St Mary and St Nicholas Church

NOTES FROM SITE VISIT.
DISCUSSED WITH RICHARD COWELL 10/11/05.
WAS ASKED TO COMMENT ON THE PROPOSED STORE
AND FENCE / EFFECT ON TREES IN CONSERVATION AREA

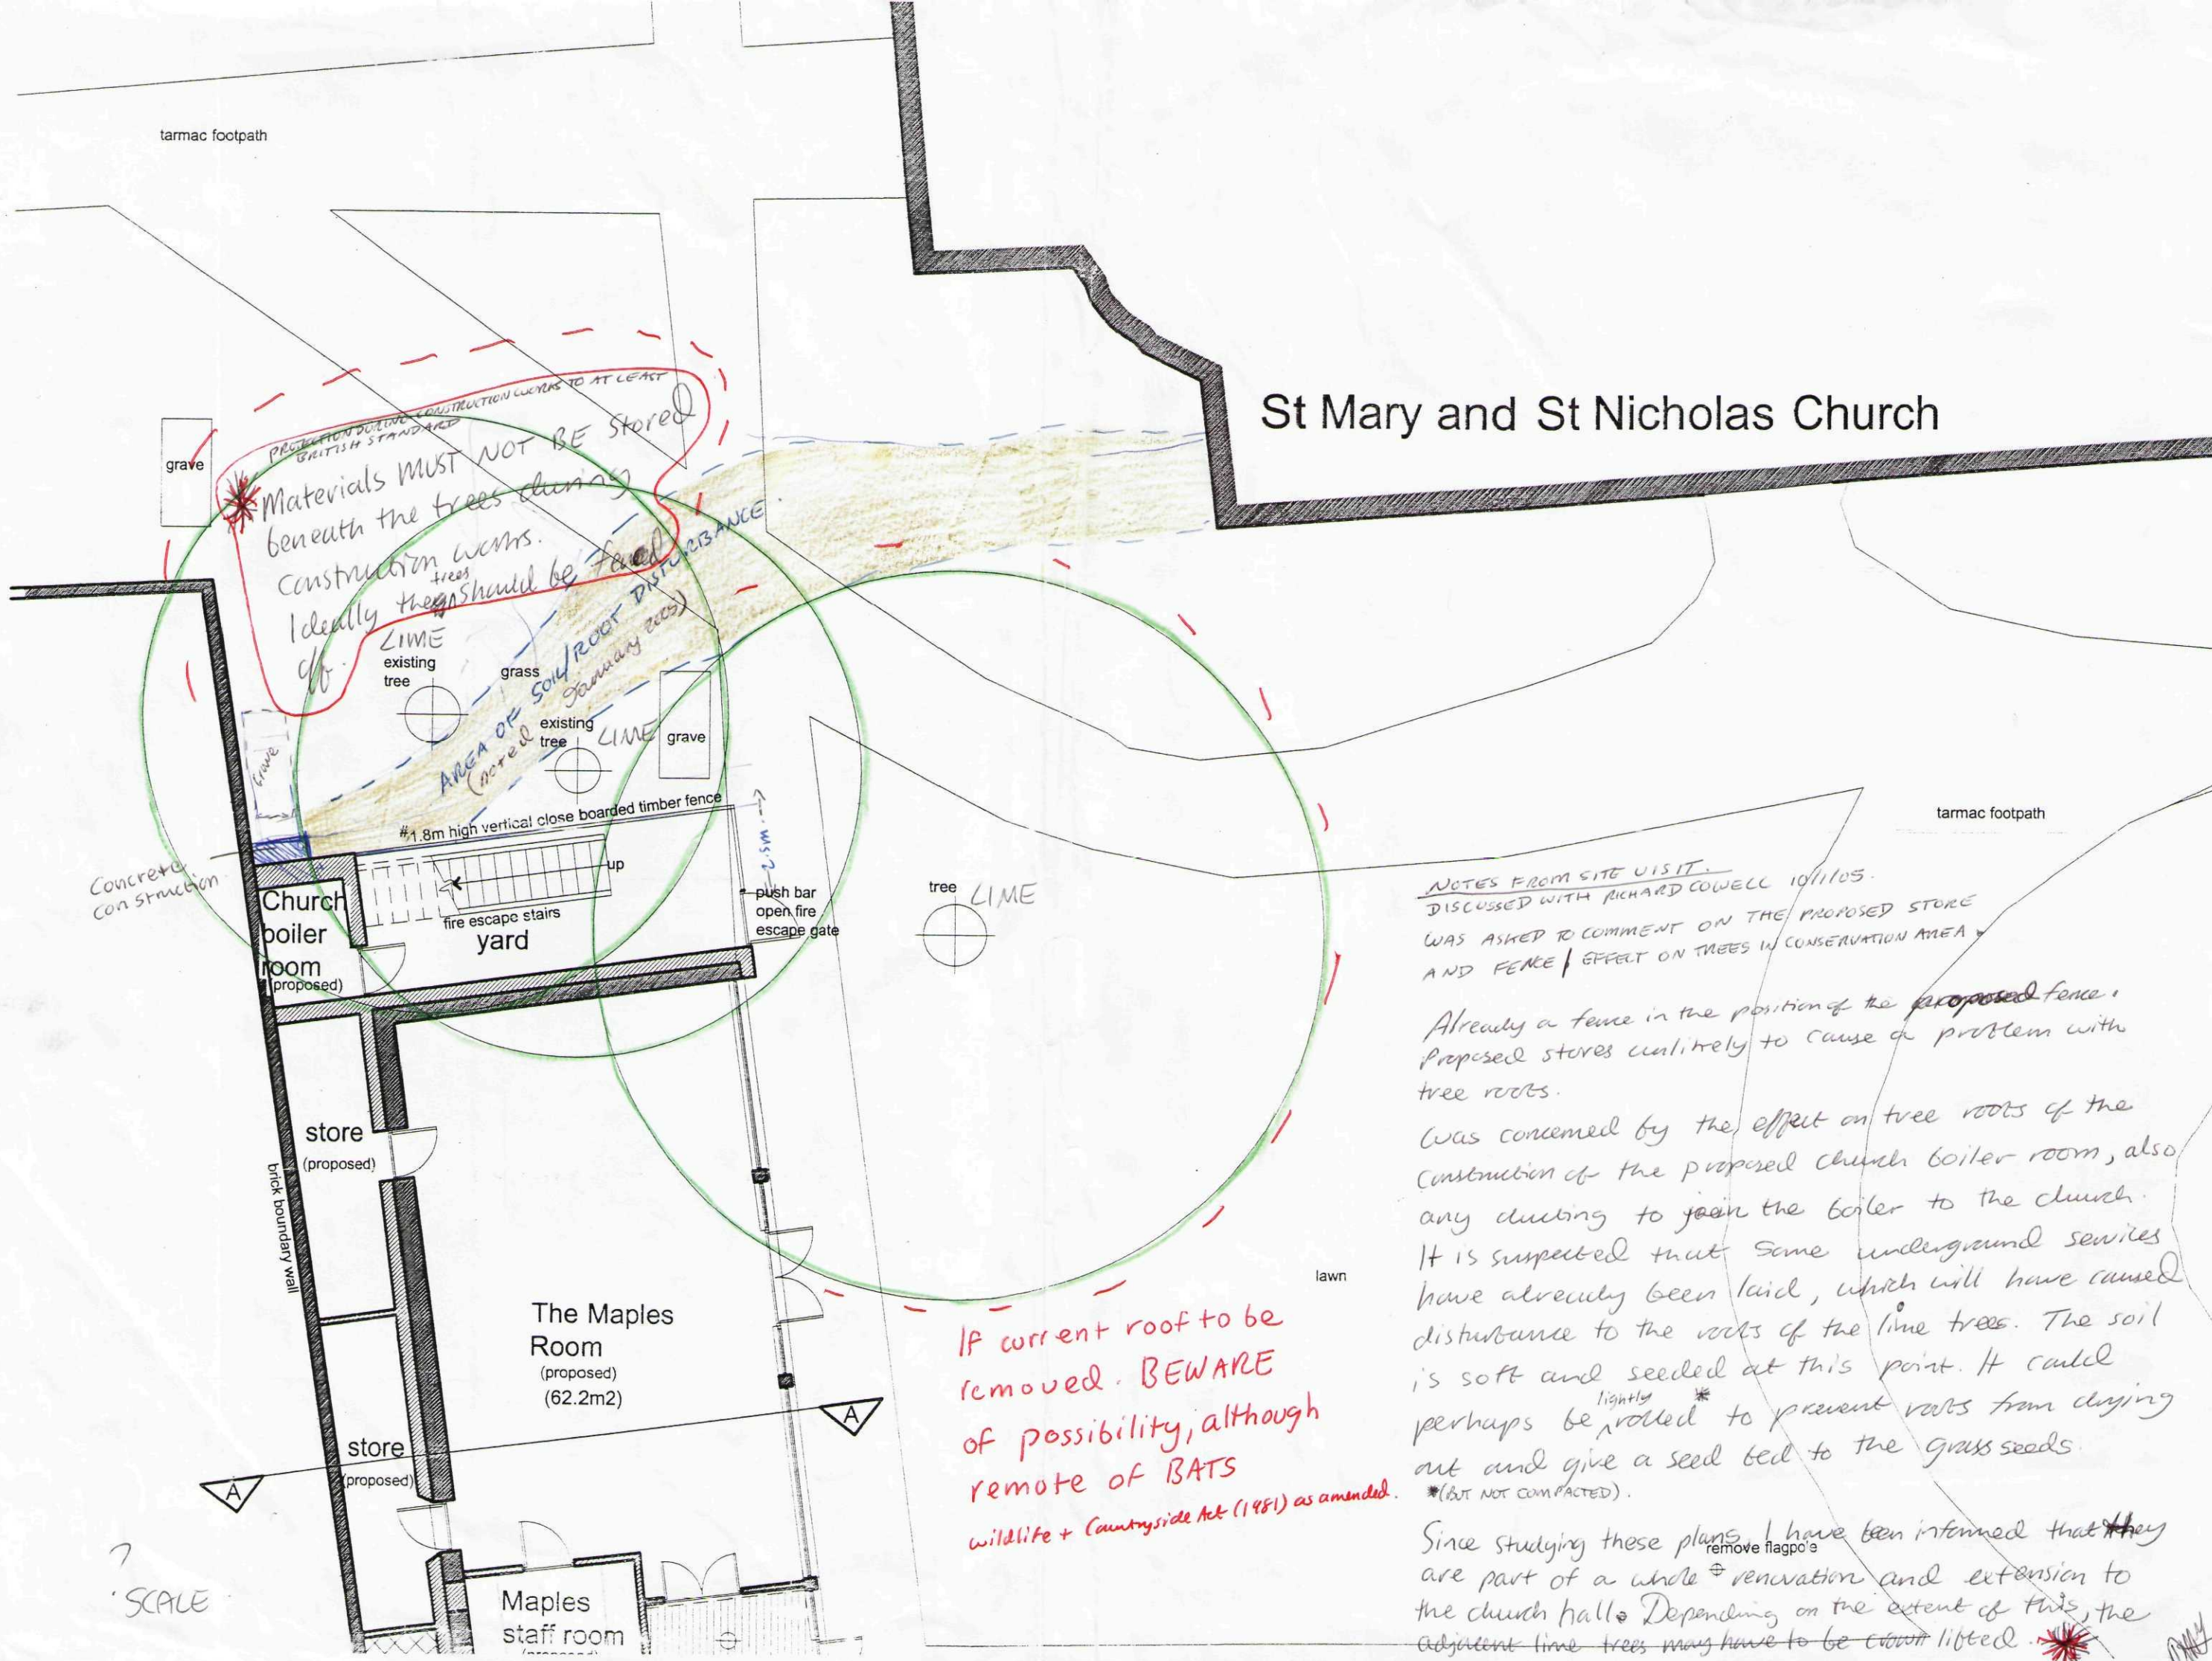
Already a fence in the position of the ~~proposed~~ fence.
Proposed stores unlikely to cause a problem with
tree roots.

Was concerned by the effect on tree roots of the
construction of the proposed church boiler room, also
any digging to join the boiler to the church.
It is suspected that some underground services
have already been laid, which will have caused
disturbance to the roots of the lime trees. The soil
is soft and seeded at this point. It could
perhaps be ^{lightly} rolled* to prevent roots from drying
out and give a seed bed to the grass seeds.

* (BUT NOT COMPACTED).
Since studying these plans, I have been informed that ~~they~~
are part of a whole ^{remove flagpoles} renovation and extension to
the church hall. Depending on the extent of this, the
adjacent lime trees may have to be crown lifted.

IF current roof to be
removed. BEWARE
of possibility, although
remote of BATS
wildlife + Countryside Act (1981) as amended.
